AMBERLEIGH SHORES

NEW HANOVER COUNTY, NC

LAST REVISED - 12/05/12 (REV 14)

FLOURNOY DEVELOPMENT COMPANY
NEW HANOVER COUNTY, NC
AMBERLEIGH SHORES
PLAN REVISION SUMMARY

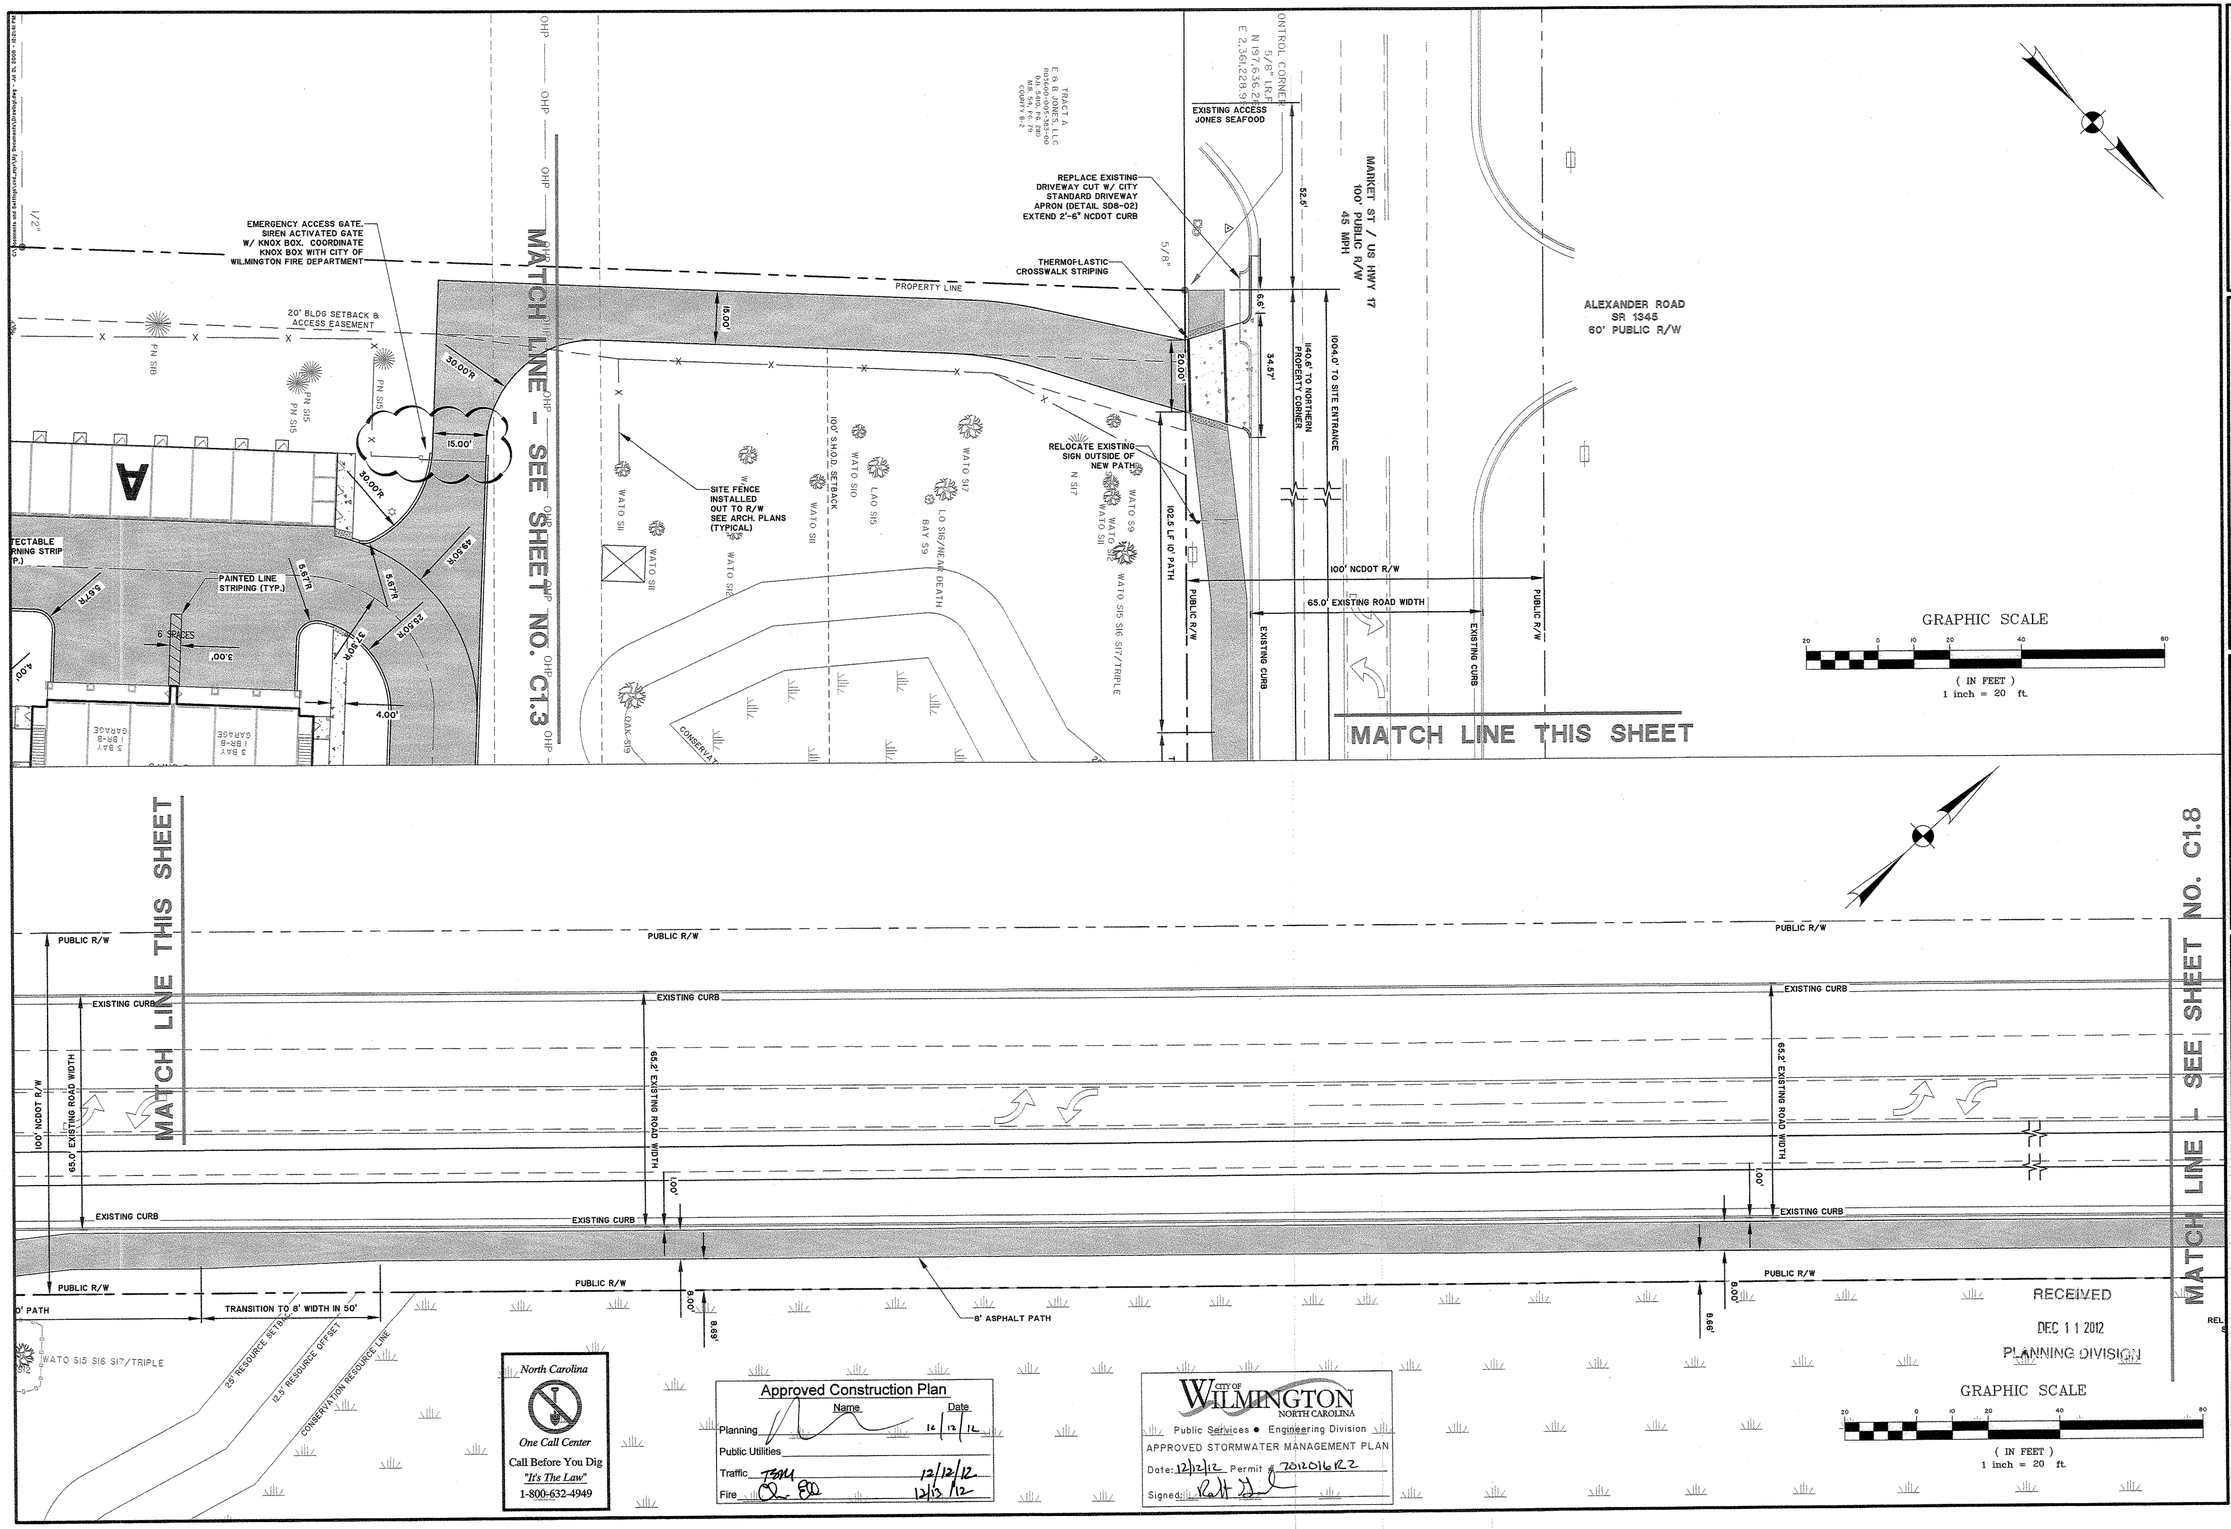
Sheet No.	Revision Comment
G1.0	Add Revision 8 Summary
C1.9	Revise Emergency Access driveway apron width to 20' per NCDOT.
C3.9	Revise spot grades on Emergency Access driveway apron.
C6.10	Delete Shark Teeth Yield line detail.

NO.	REVISIONS	BY	DATE
14	REV. EMERGENCY GATE SYMBOL & FENCE LOCATION	BDR	12/05/12
9	REVISE EMERGENCY ACCESS DRIVEWAY LOCATION	BDR	07/20/12
8	REVISE EMERGENCY ACCESS APRON WIDTH TO 20'	BDR	07/05/12
6	SEE REVISION SUMMARY ON SHEET G1.0	BDR	05/18/12
4	SEE REVISION SUMMARY ON SHEET G1.0	BDR	04/02/12

EC.0

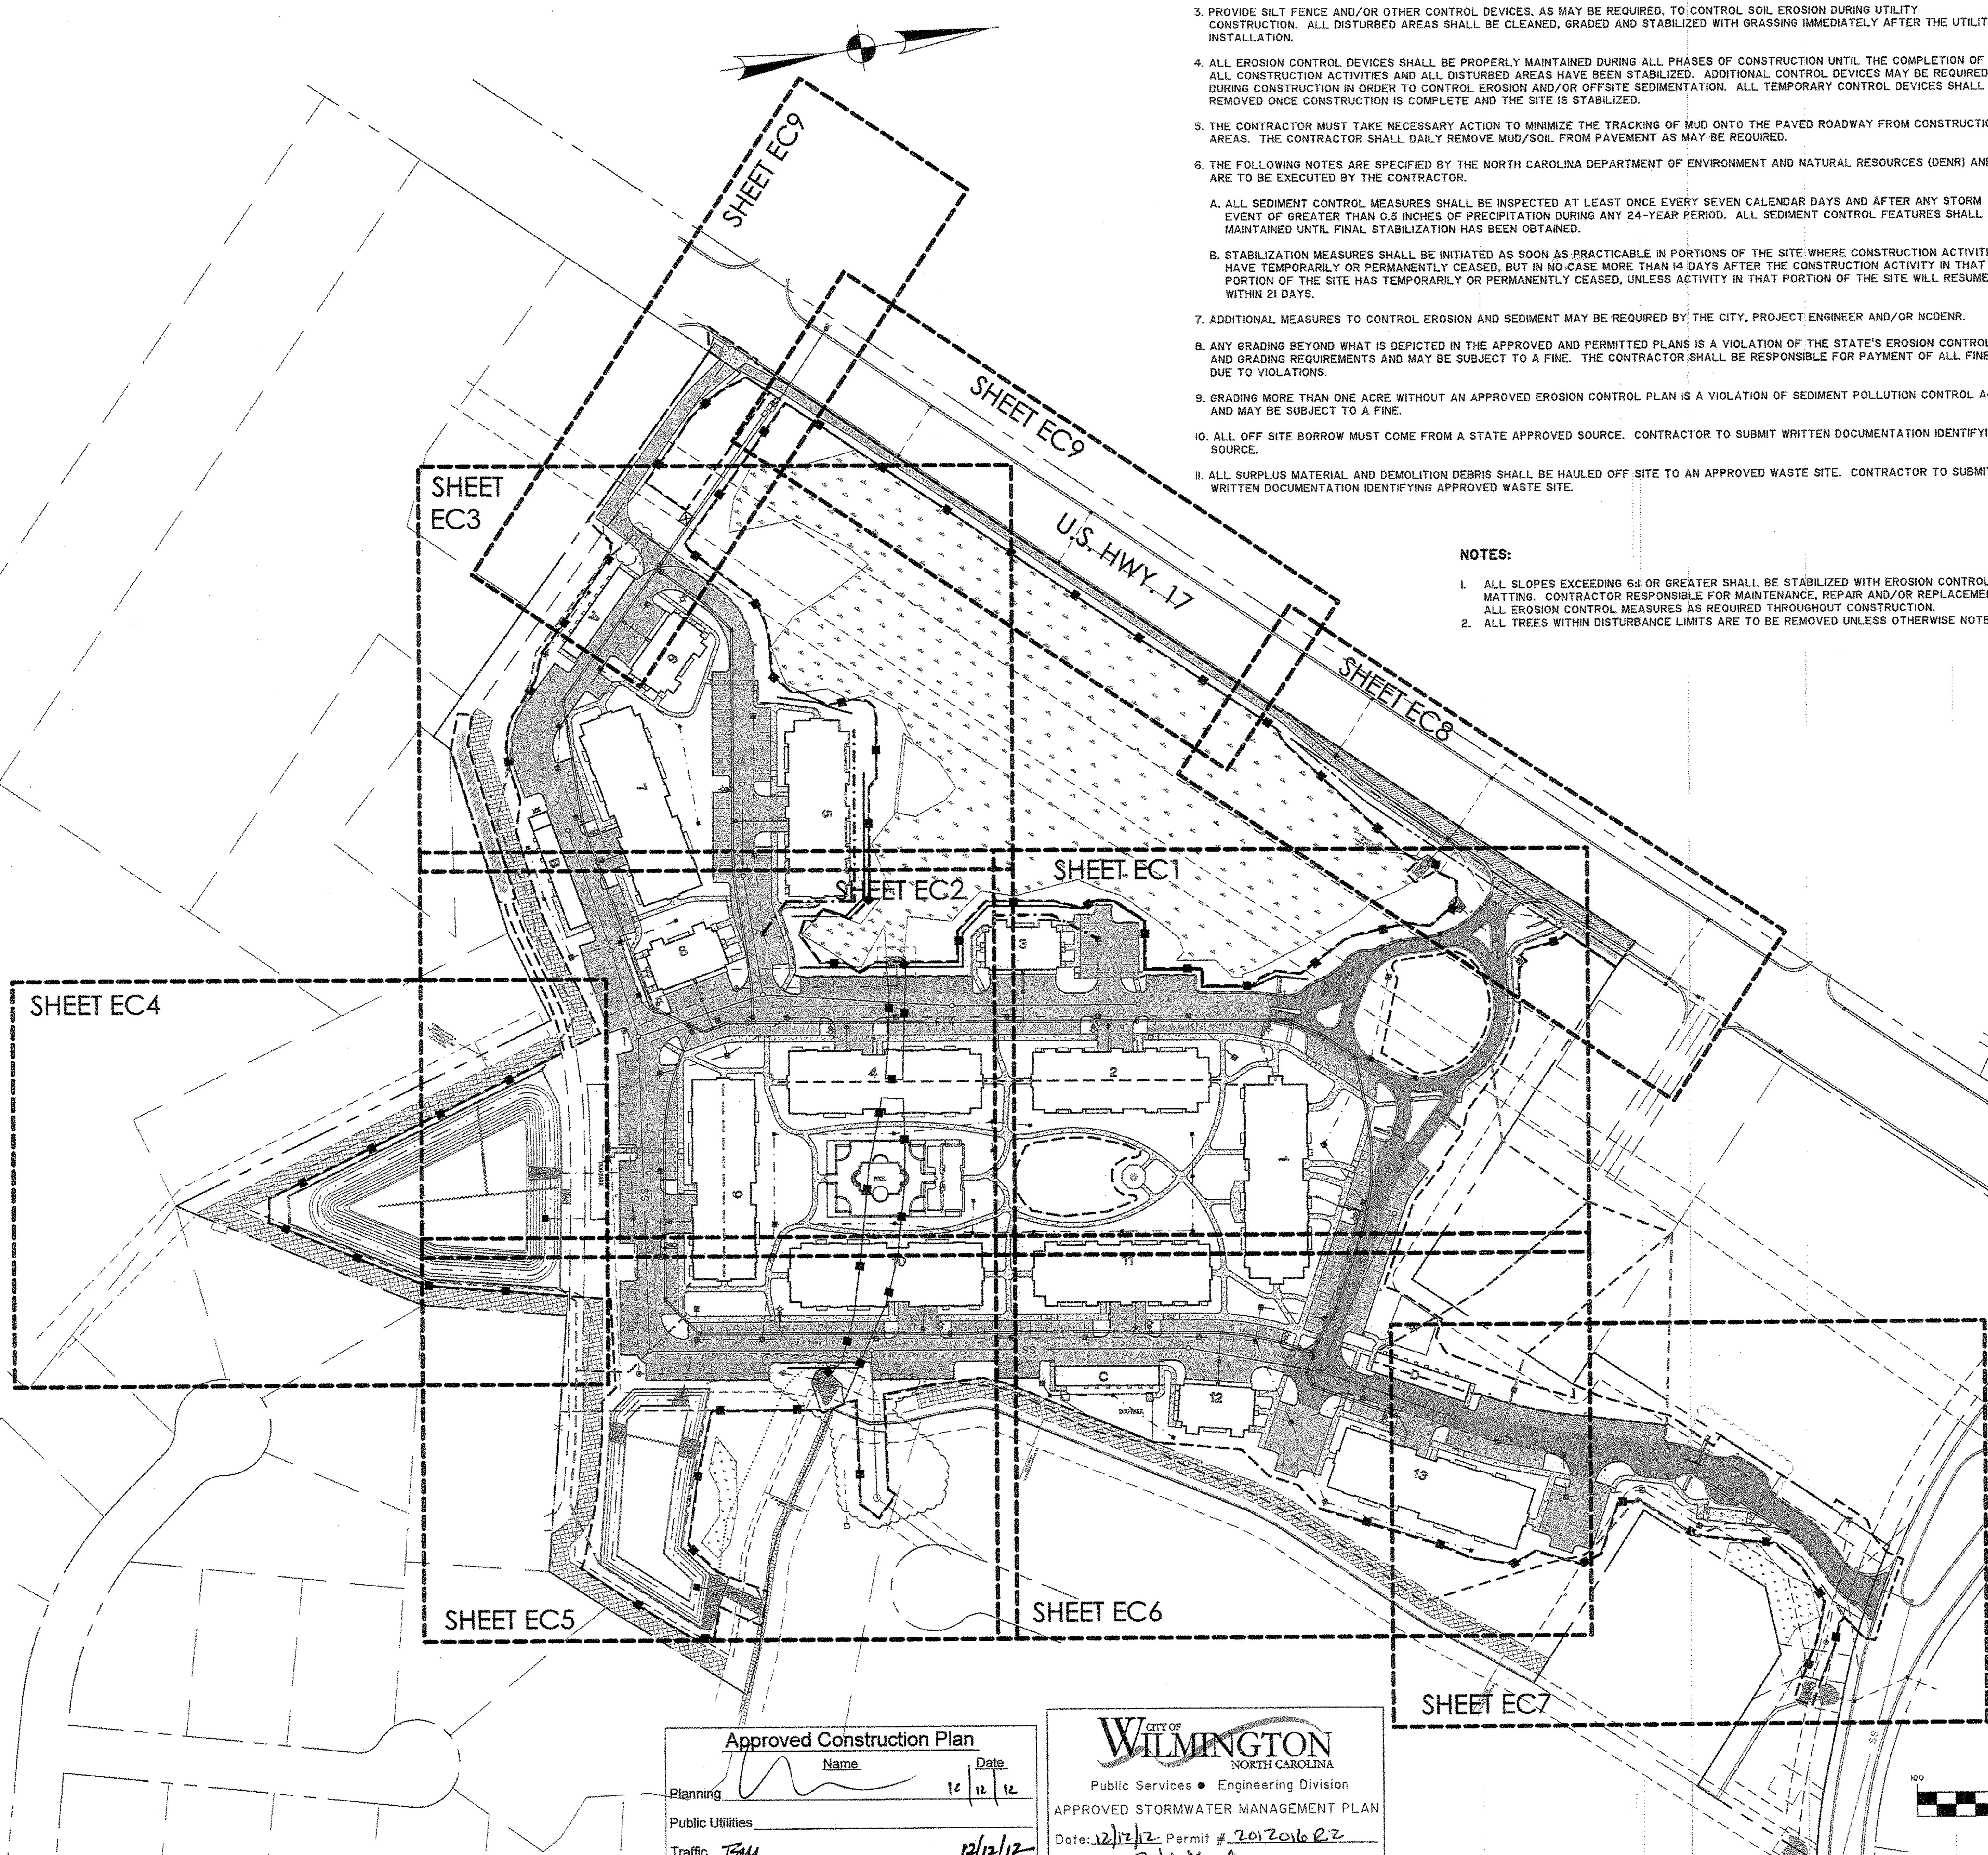
Sheet No.	Revision Comment
G1.0	Add Revision 13 Summary.
G1.2	Revise clearing limit location on NE corner of site for the storm pipe outfall.
EC.0	Revise clearing limit location on NE corner of site for the storm pipe outfall.
EC.7	Revise clearing limit location on NE corner of site for the storm pipe outfall.
C3.7	Add label for Storm Manhole #92 and upstream pipe.

NO.	REVISIONS	BY	DATE
14	SEE REVISION SUMMARY ON SHEET G1.0	BDR	12/05/12
13	REVISE CLEARING & SILT FENCE LIMITS FOR STORM PIPE	BDR	09/13/12
12	ADD PREVIOUS REVISION NOTES	BDR	08/27/12
11	SEE REVISION SUMMARY ON SHEET G1.0	BDR	08/07/12
10	SEE REVISION SUMMARY ON SHEET G1.0	BDR	07/24/12
9	REVISE EMERGENCY ACCESS DRIVEWAY LOCATION	BDR	07/20/12
6	SEE REVISION SUMMARY ON SHEET G1.0	BDR	05/18/12
4	SEE REVISION SUMMARY ON SHEET G1.0	BDR	04/23/12
1	SEE REVISION SUMMARY ON SHEET G1.0	BDR	01/25/12

C2.0

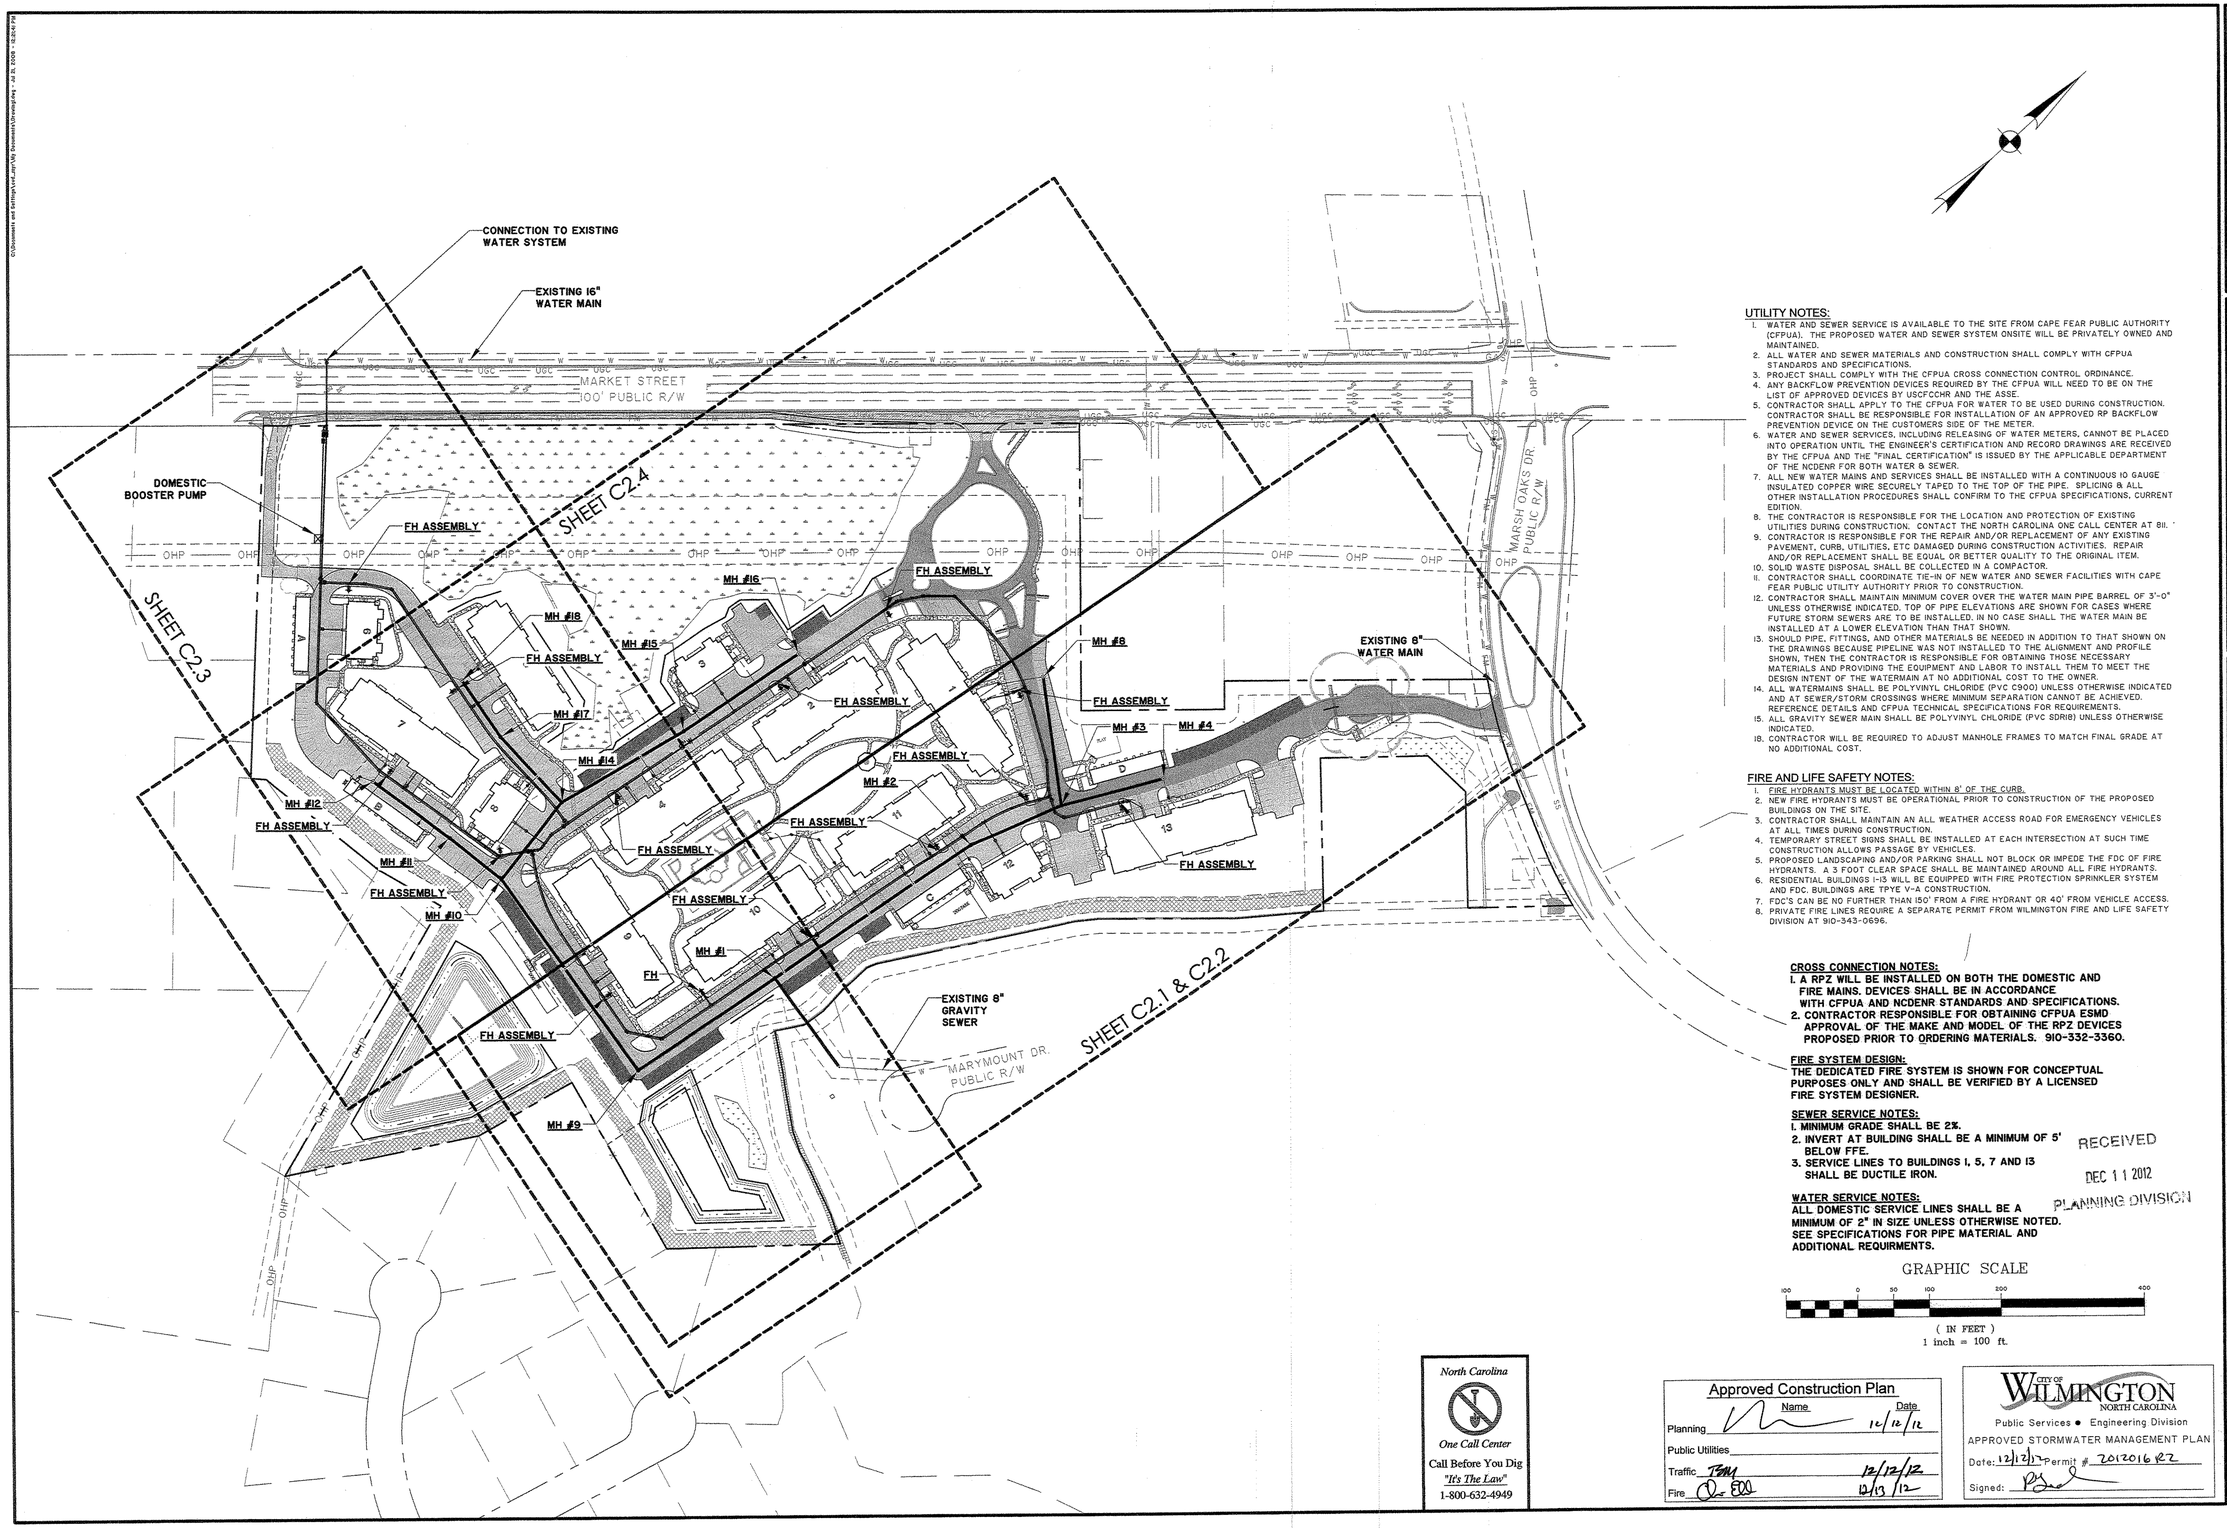
Sheet No.	Revision Comment
C2.0	Revise water and sewer infrastructure to be privately owned and maintained with 4" master meter (domestic) and separate, dedicated fire main loop. Add Domestic Booster Pump. Revise Fire Hydrant locations. Update Notes.
C2.1	Delete water connection to Marsh Oaks Dr. Revise watermain sizes. Revise Fire Hydrant and valve locations. Delete MH's 5 & 6. Relocate MH 4 & 8. Raise sewer from MH 1-4 and 4-8.
C2.2	Revise watermain sizes. Revise Fire Hydrant and valve locations. Delete MH 19. Raise sewer from MH 1-4 and 4-8.
C2.3	Revise watermain sizes. Add 4" domestic master meter with 6" RPZ. Add 10" RPZ for dedicated fire main loop. Revise Fire Hydrant and valve locations. Delete MH 13. Revise MH 12 & 18 location. Move water service location to left side of Bldg 8. Add Sand and Oil/Water Interceptor Detail for carwash drain.
C2.4	Revise watermain sizes. Revise Fire Hydrant and valve locations. Revise MH 16 location.

Sheet No.	Revision Comment
C2.0	Revise Utility Note #14. Add Cross Connection Note #2.
C2.1	Raise water main crossing over sewer between MH 2 & 3.
C2.3	Change sewer material to DIP between MH 17 & 18 and specify DIP water main crossing over same sewer run. Change tee and reducer configuration at meter location.
1/4 - 4/4	Replace Sanitary Sewer Detail sheets with new issue from CFPUA
1/2 - 2/2	Replace Water Detail sheets with new issue from CFPUA
